APPLICATION NO.	FILING DATE	FIRST NAMED INVENTOR	ATTORNEY DOCKET NO.	CONFIRMATION NO.
10/656,506	09/04/2003	Paul Anthony Halstead	33528/RFT/VEJ	8021
32940	7590	02/24/2005	EXAMINER	
DORSEY & WHITNEY LLP INTELLECTUAL PROPERTY DEPARTMENT 4 EMBARCADERO CENTER SUITE 3400 SAN FRANCISCO, CA 94111			BRITTAINE, JAMES R	
		ART UNIT		PAPER NUMBER
		3677		
DATE MAILED: 02/24/2005

<i>Office Action Summary</i>	Application No.	Applicant(s)	
	10/656,506	HALSTEAD, PAUL ANTHONY	
	Examiner	Art Unit	
	James R. Brittain	3677

DETAILED ACTION

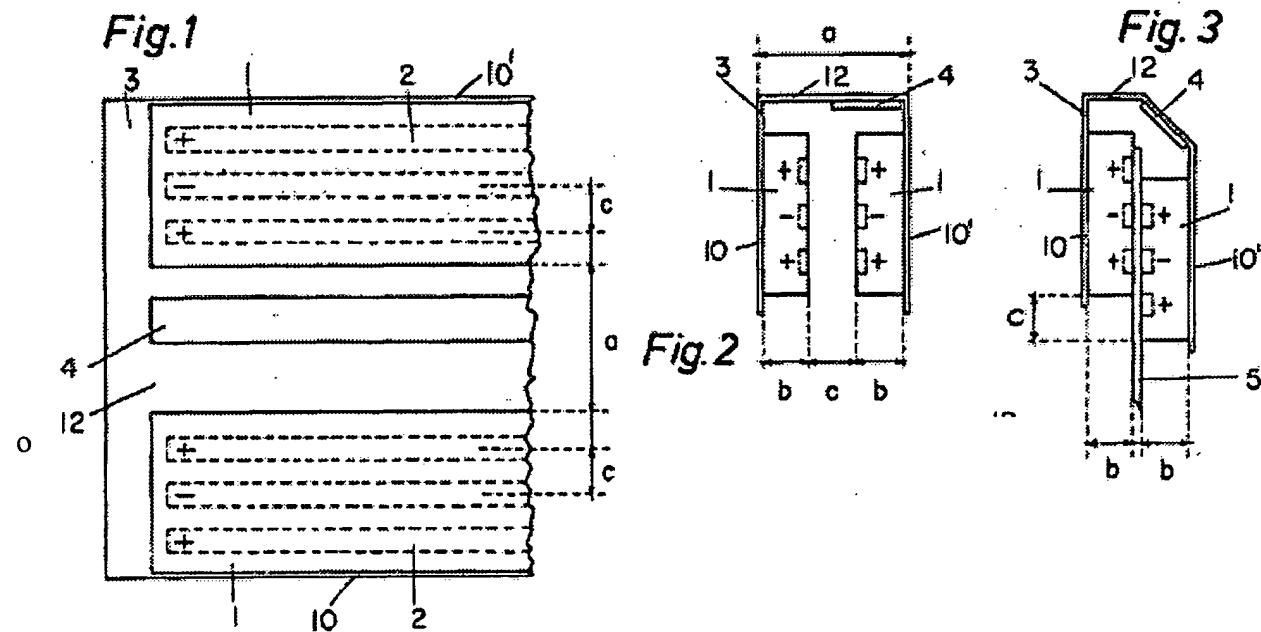
Hutter (figures 1-3) teaches a clip for holding paper and therefore inherently capable of holding banknotes having a first clasp portion 10' and a second clasp portion 10 for holding banknotes therebetween, the first clasp portion having a first magnetic portion 1 including magnetic material and the second clasp portion having a second magnetic portion 1 including magnetic material, wherein the first magnetic portion is moveable relative to the second magnetic portion between: a closed position whereby the interaction of the magnetic material of

the first and second magnetic portions is such that there is a net force of attraction to hold the first and second clasp portions together; and an open position whereby the first and second clasp portions are released apart. Figure 1 shows that there are spaced bands 2 of alternating polarity sequentially arranged across the width of the clamp and generate an open configuration when the facing polarities are alike (figure 2) and a closed configuration when the facing polarities are opposite (figure 3). The polarity of each band 2 inherently reverses through the thickness of the band. A flexible hinge connects the two clasp portions together and permits the requisite movement for the operation of the clasp (col. 4, lines 57 - col. 6, line 3 and col. 6, lines 10-15). The edges of the clasp portions are grippable and function as an activator portion for relative manual movement of the first magnetic portion as shown in the below figures.
